**Gas cylinders — Cylinder valves —
Specification and type testing**

**AMENDMENT 1: Pressure drums and
tubes**

Reference number
ISO 10297:2014/Amd.1:2017(E)

Amendment 1 to ISO 10297:2014 was prepared by Technical Committee ISO/TC 58, *Gas cylinders*, Subcommittee SC 2, *Cylinder fittings*.

Figure F.1 — Typical arrangement of a computer controlled test machine

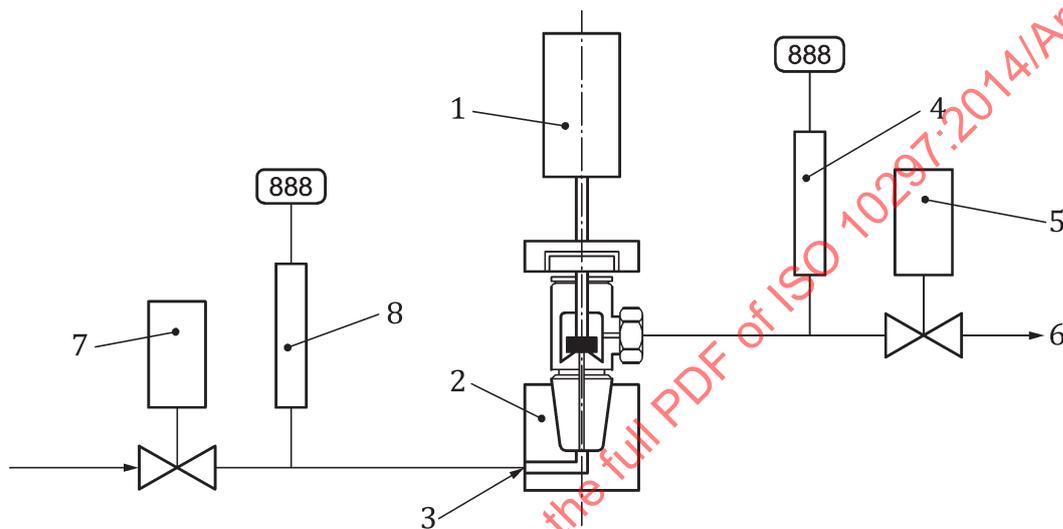
F.1, figure

Delete “a” and “b” from the figure and the key.

Replace Figure F.1 with the following:

- 1 DC motor with torque transmitter
- 2 test sample with adapter
- 3 input test medium
- 4 high pressure transducer with display
- 5 venting valve
- 6 outlet
- 7 valve
- 8 inlet high pressure transducer with display for monitoring of p_{vt}
